MEMO

SUBJECT: Alleghany Co. LF
GW qual asmt.
Approx. 6 Acres fill

03-01
Ashe Co LF
5/31/95
site visit

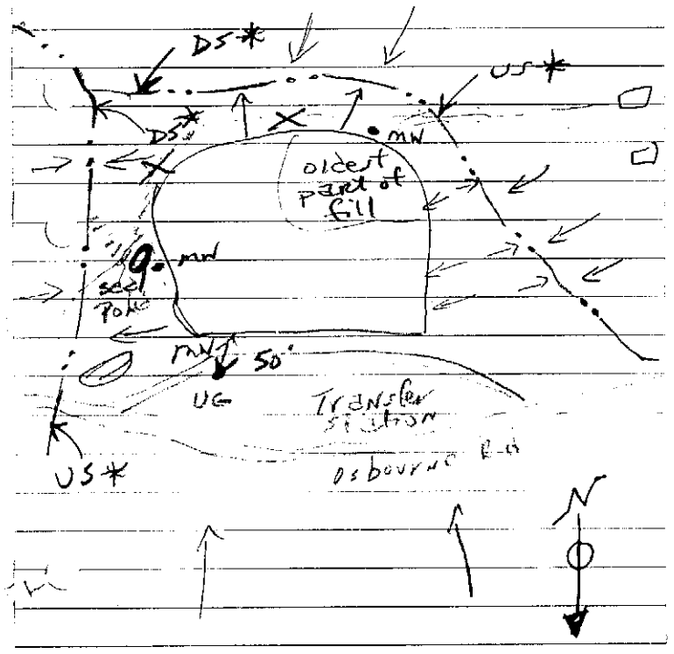
mw's not grouted - need replacing - no mw records

Leachate seeps noticed during past insp. on east side of LF (per B. Rockett)
